Video Products Technical Bulletin 30-2005-133

SUBJECT: REUSE IC712 WHEN REPLACING B BOARD

MODEL: ***PVM-20M7MDE***SERIAL NO: **ALL**

Figure 1

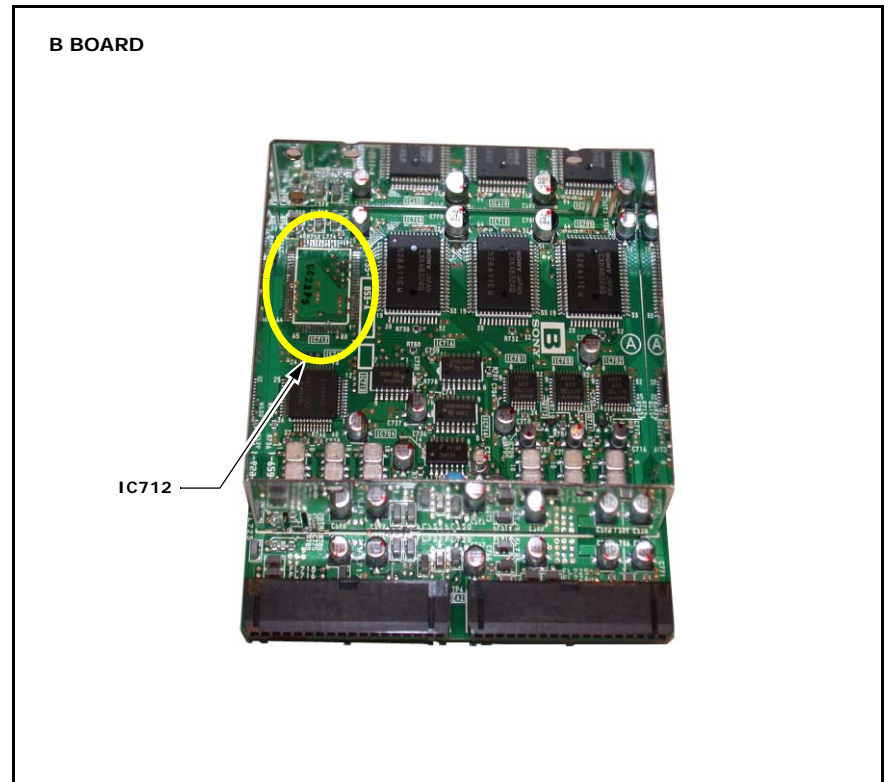
The new B board does not contain IC712, and IC712 is no longer available as a service part. (See Figure 1.)

When you replace the B board (A-1135-853-A), remove IC712 (8-752-328-71, IC CXD2000Q) from the former board and install it on the new board.
